UCID-20769

TECHNICAL EVALUATION REPORT - STRUCTURAL DESIGN ISSUES
LONG-TERM-SERVICE SEISMIC REEVALUATION
SOUTHERN CALIFORNIA EDISON COMPANY
SAN ONOFRE NUCLEAR POWER GENERATING STATION UNIT 1

Lawrence Livermore National Laboratory

Integrated Safety Assessment Program
Office of Nuclear Reactor Regulation
U. S. Nuclear Regulatory Commission
Washington, D. C. 20555

Figure 8. The foundation-level and free-field in-structure response spectra.

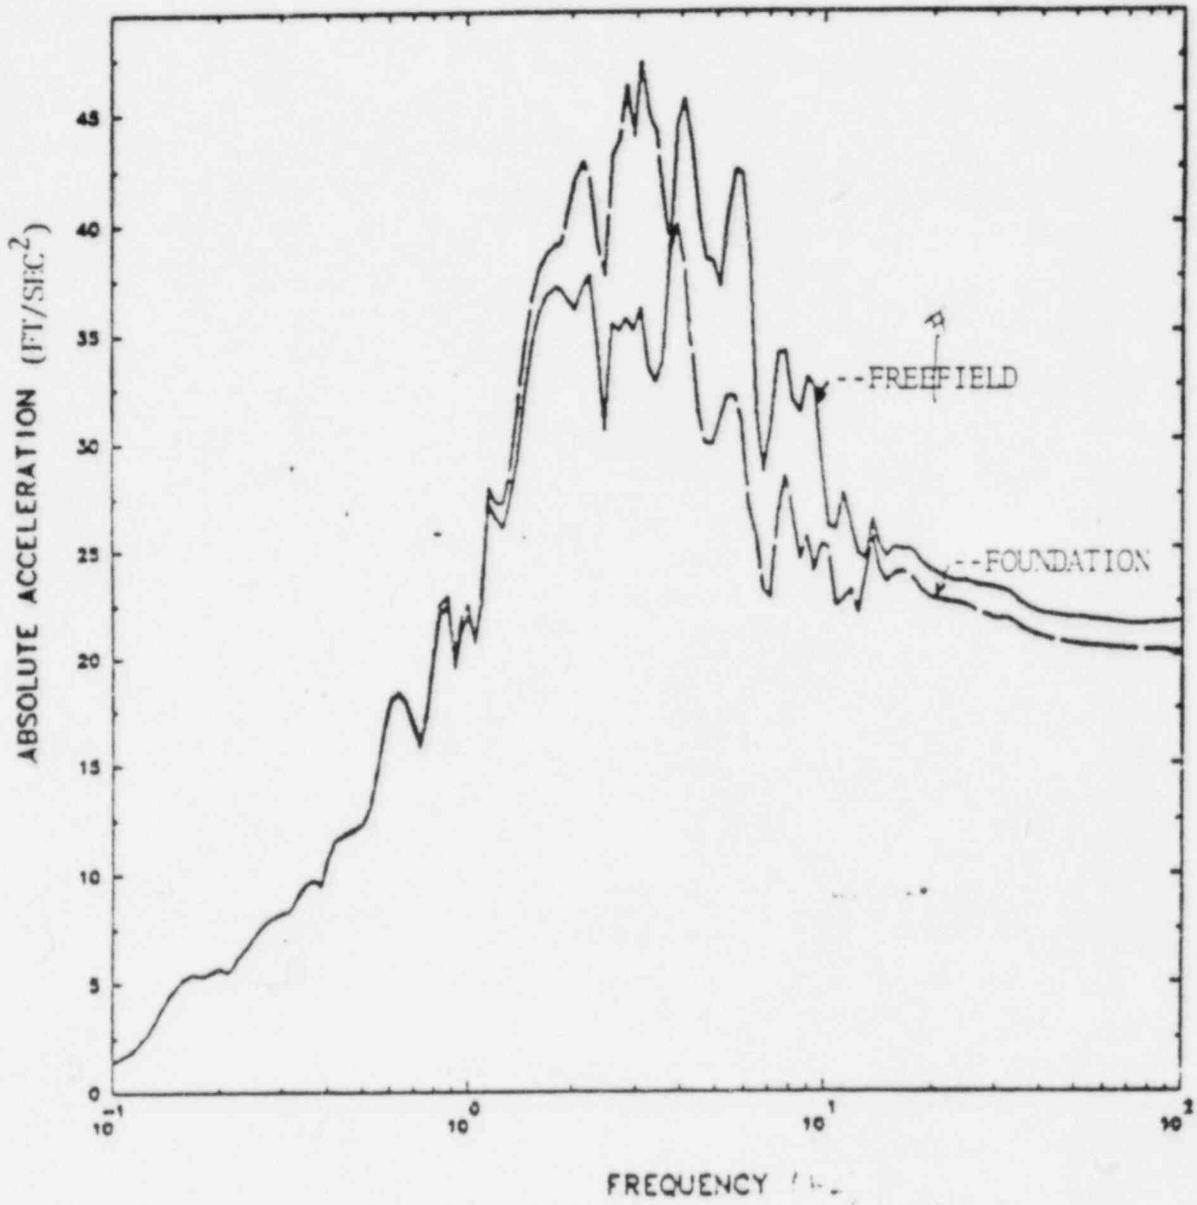
Figure 8 shows that, based on the CLASSI approach the in-structure response spectrum at the foundation level is generally lower than that in the free-field. Figure 9 shows the peak accelerations along the structure elevation. It can be seen from Figure 9 that the accelerations decrease slightly at the lower part of the structure, then increase all the way up to the tank roof.

Figure 10. Peak acceleration response, based on the frequency-independent impedance approach (constant spring).

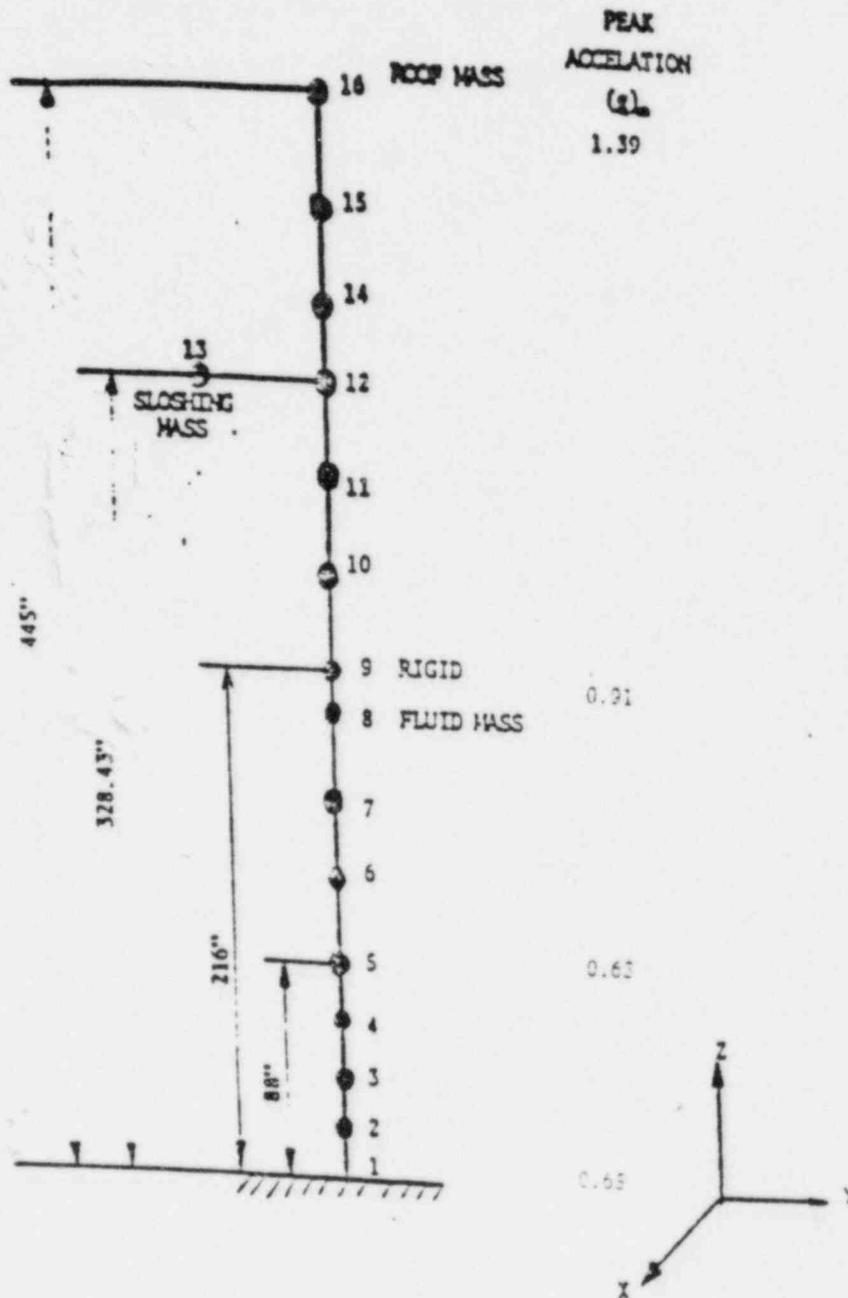
Figure 10 shows the peak accelerations along the structure elevation, based on the frequency-independent impedance calculation. Again, the accelerations decrease at the lower part of the structure, then increase all the way up to the tank roof.

Figure 11. Impell's peak acceleration response, based on the frequency-dependent impedance approach.

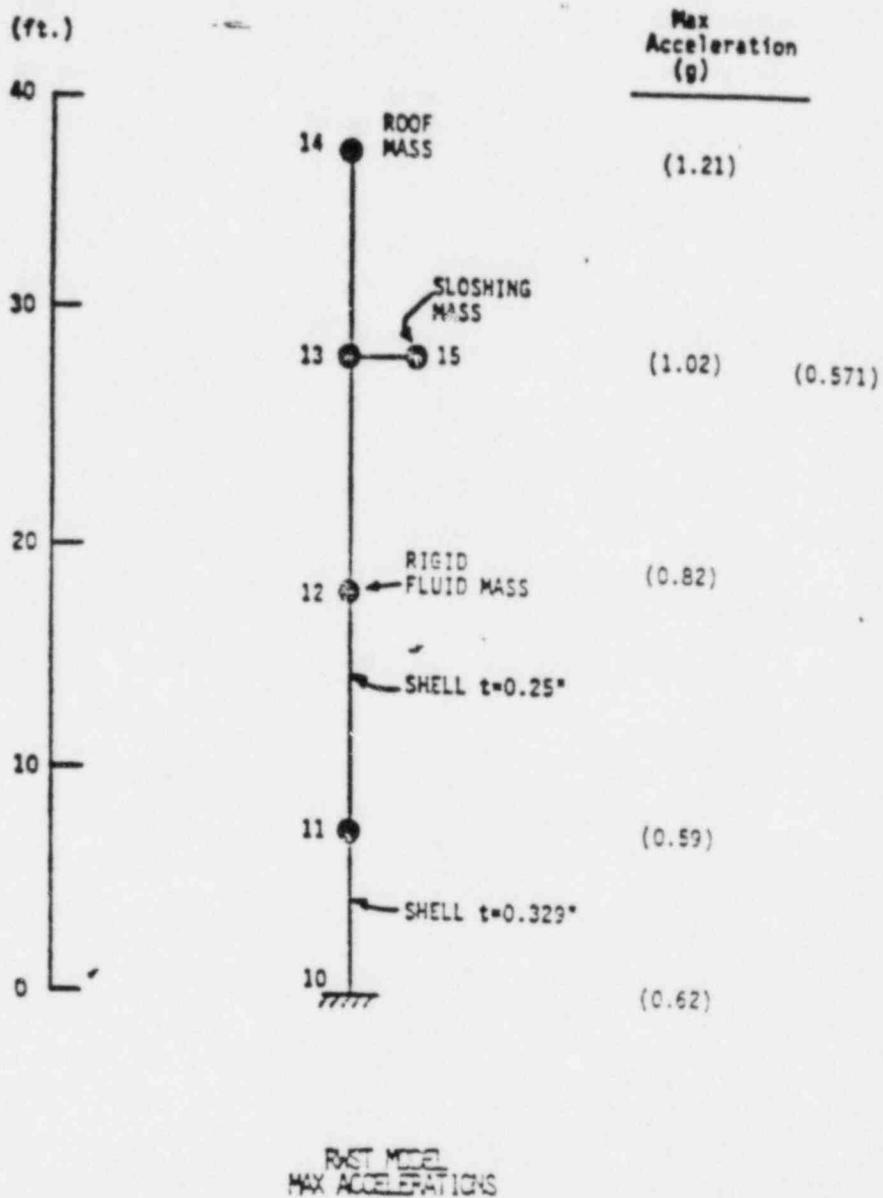
Impell's response results (Ref. 2.2) are shown in Fig. 11. By comparing LLNL's CLASSI and Impell's response results, we see the second decimal place. Accordingly, we conclude that the results of the soil-structure-fluid analysis performed by Impell are acceptable.
